10/619,333

COMMENTS

Claims 6-13 and 29-33 Fully Comply With The Requirements of 35 U.S.C. § 112, First Paragraph

position of the first intake device, Applicants respectfully direct the Examiner to Figure 1 (reproduced below) which shows an ECU 90 connected to a throttle valve position sensor 218.

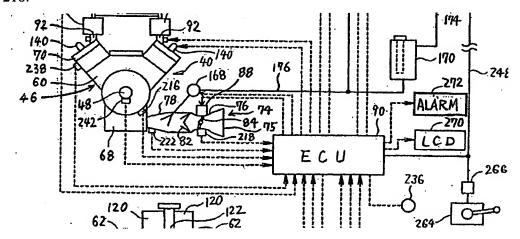
The drawings stand objected to for failing to illustrate a "control device to detect a first intake device and a secondary intake device." Page 2 of the outstanding Office Action. With respect to the recitations in the claims directed to a control device for detecting the

However, with respect to the portion of the present objection directed to "a control to detect a . . . secondary intake device," Applicants respectfully point out that none of the pending claims include such a recitation. Thus, Applicants submit that there is no basis for requiring that the drawings illustrate a control device "for detecting the secondary intake device."
